# Office Action Summary

10/522,507

PEREVERZEV, IGOR

**DETAILED ACTION**

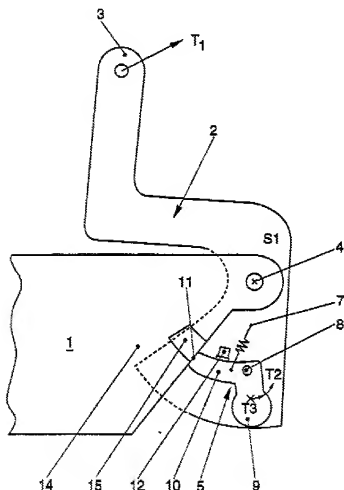
4. Regarding claim 1, Koeppen shows a latch mechanism for selectively latching a door to an automotive vehicle, said latch mechanism comprising a latch hook (see abstract; locking mechanism) movable between a locked position and an unlocked position, a release lever (1) operatively coupled to said latch hook for selectively moving said latch hook between said locked and unlocked positions; and an inertia lever (2) engageable with said release lever to prevent movement of said latch hook between said locked and unlocked positions, said inertia lever movably supported within said latch mechanism for moving in and out of engagement with said release lever in response to a side impact upon the vehicle (see abstract for explanation of motion

relative to change in acceleration); wherein said release lever includes a slot (15) presenting sides for engaging a portion of said inertia lever for automatically toggling said inertia lever in response to movement of said release lever to prevent seizing of said inertia lever within the latch mechanism. See the Koeppen device below.

5. Regarding claim 2, Koeppen shows a means for biasing (7) the inertia lever to a first position out of engagement with said release lever.

6. Regarding claim 3, Koeppen shows the inertia lever has a tab (11) and said slot of said release lever is aligned with and engages the tab when the release lever is actuated to unlock the latch hook and the inertia lever is in the first position (see figure 2 where 11 is in 15 allowing rotation).

7. Regarding claim 4, side impact moves the inertia lever to a second position (figure 3) so that the tab and slot are not aligned.
8. Regarding claim 5, the inertia lever is pivotally mounted within said latch mechanism (pivot point T1).
